Oxford Commons

Mobile Manufactured Housing Community

Oxford, Connecticut

King's Mark Environmental Review Team Report

EXHIBIT #1

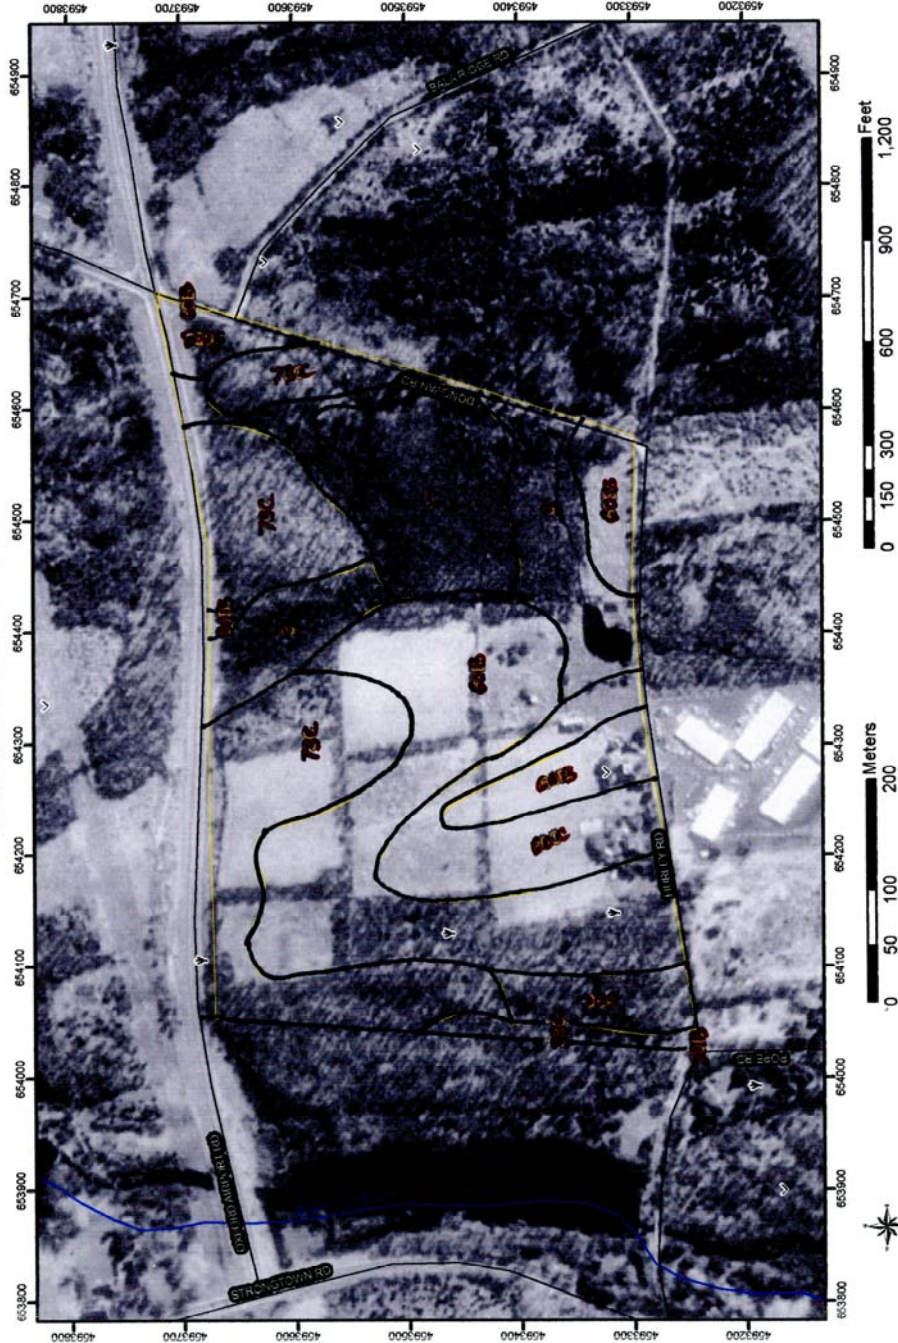
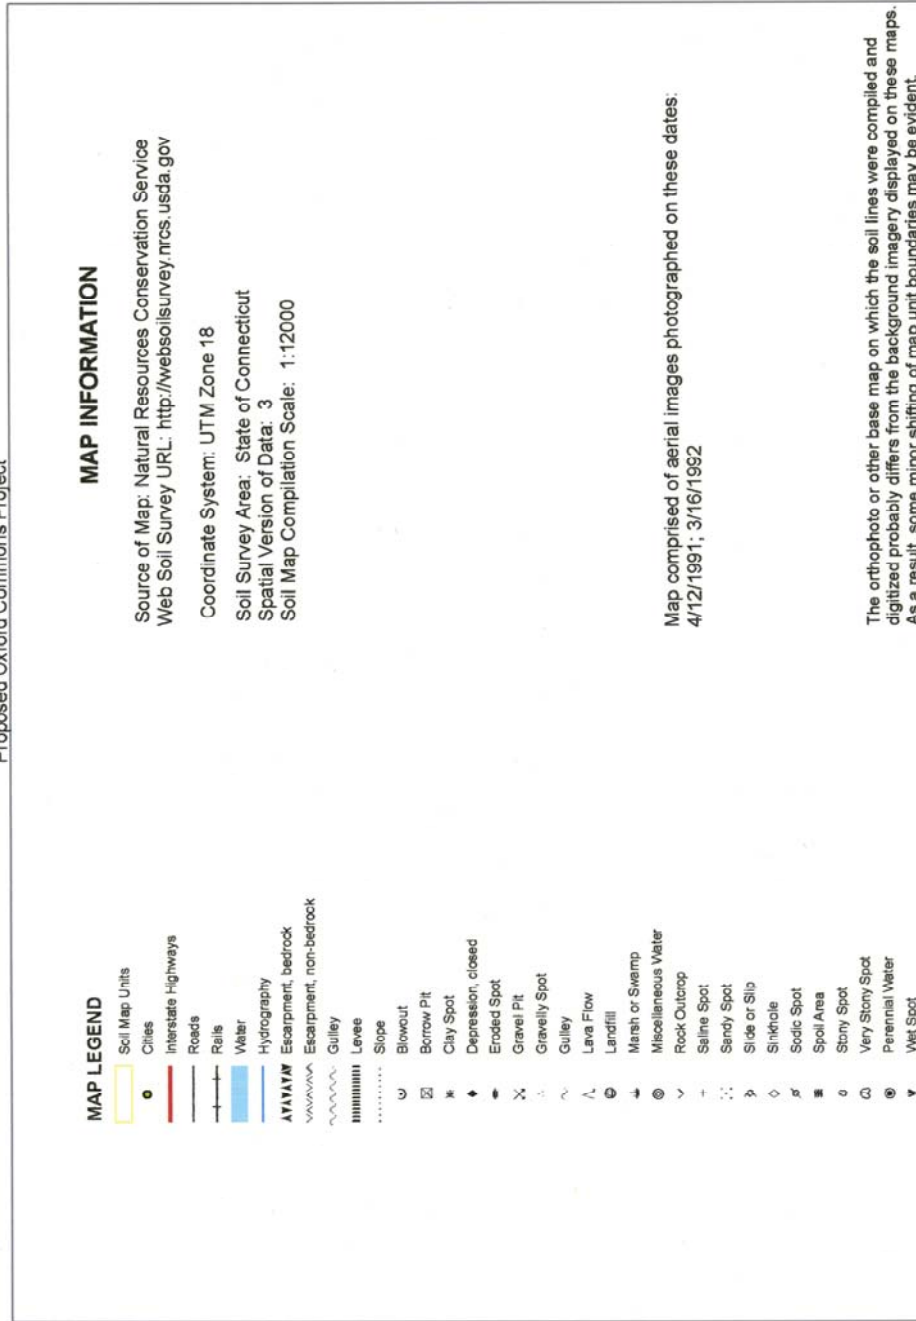
The historical reference for soils regarding this region can be found in sheet number 25 of the 1979 New Haven County Survey. Exhibit #1 - CT Soils Mapping is derived from the new digital survey (Soil Survey of Connecticut). The soil survey utilizes recent aerial photographic base with one soil legend, which employs the numbering convention used by the USD A.
